## *Town of Brookline Massachusetts*

To: Brookline Board of Appeals  
From: Brookline Planning Board  
Date: April 30, 2015  
Subject: Construct a second enclosed parking space at the basement level at rear façade; construct a deck over the second garaged space and add 184 square feet of living space off first floor at the rear  
Location: 98 Spooner Road  
Atlas Sheet: 66 Case #: 2015-0022  
Block: 281 Zoning: S-10  
Lot: 22 Lot Area (s.f.): ± 10,095.5 sf

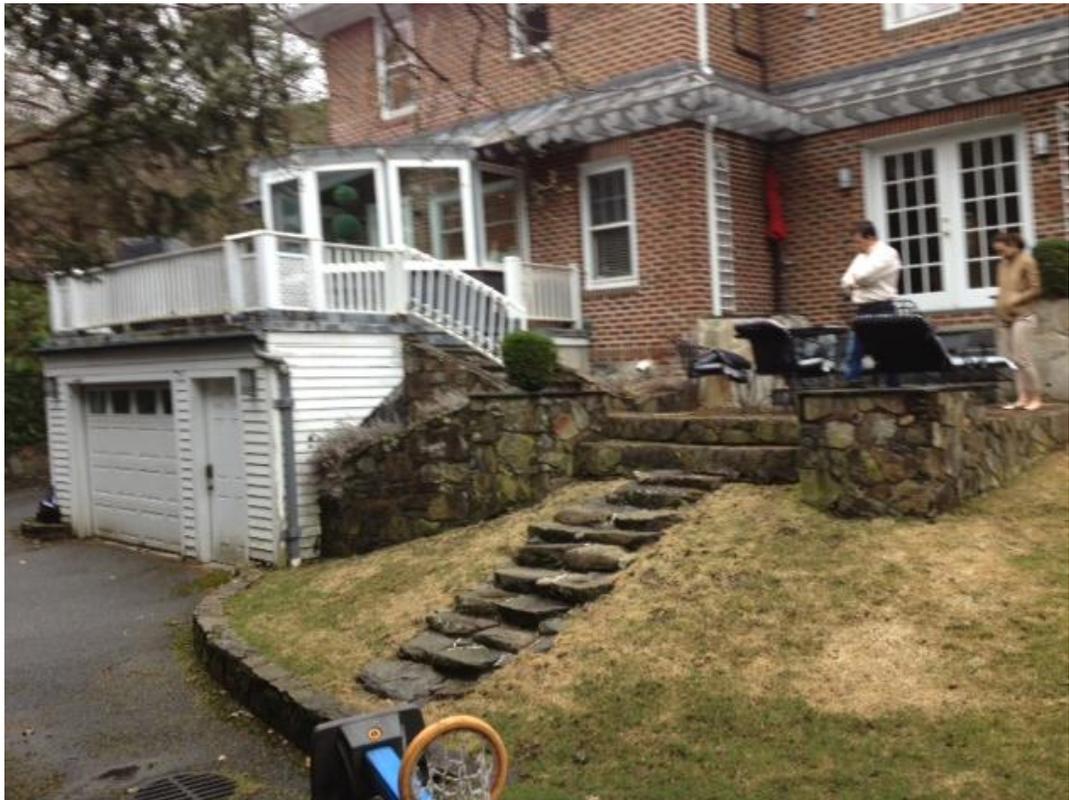
Side façade: hood, stairs will be removed

Rear yard between garage and rear property line; view of west side abutters

View of rear property line and screening

View of rear façade and area of proposed construction. Solarium, existing steps and landing will be removed.

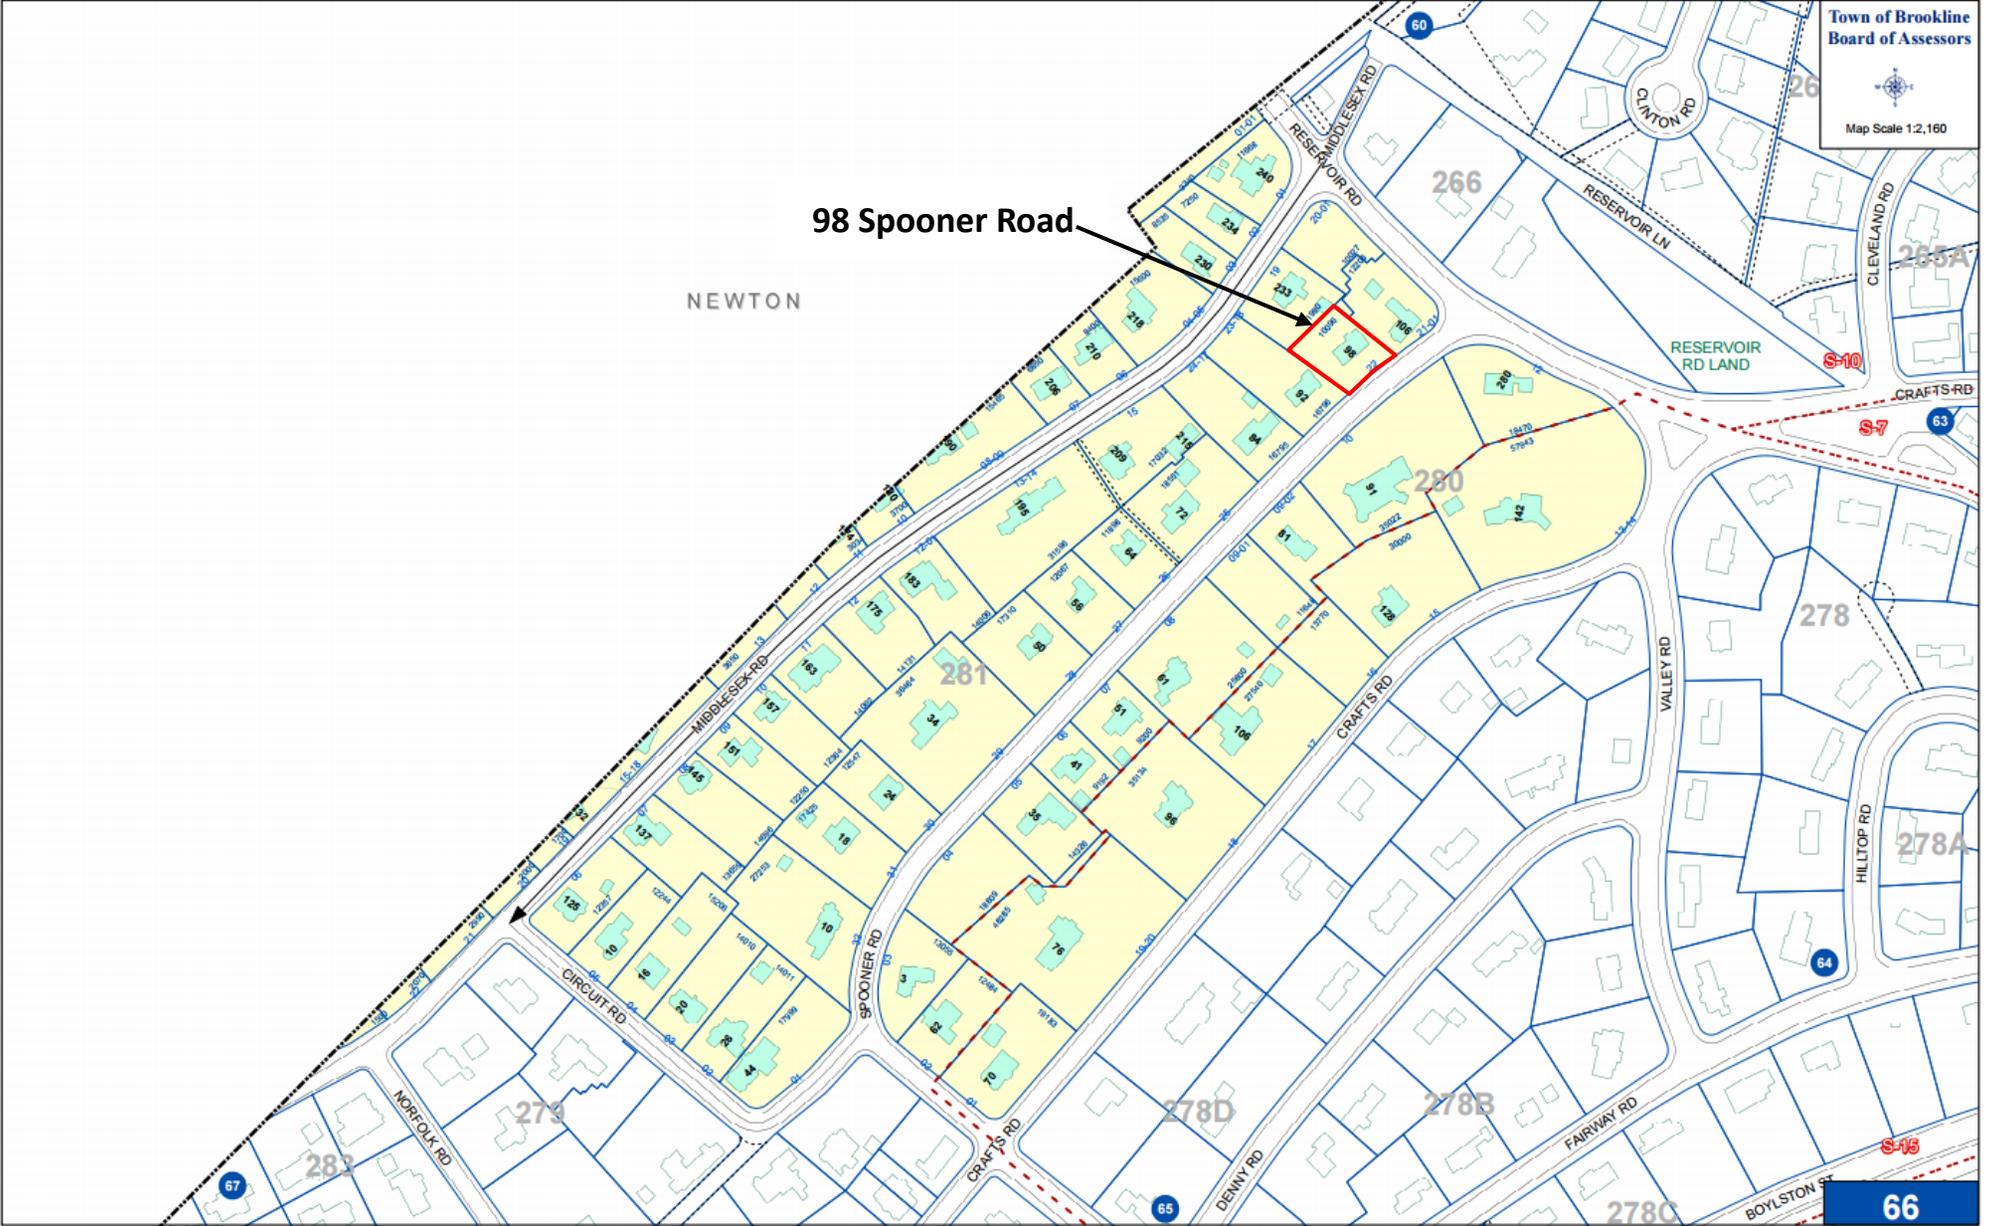
View of rear façade, and east side abutter.

Rear façade; French doors will provide egress to the new terrace
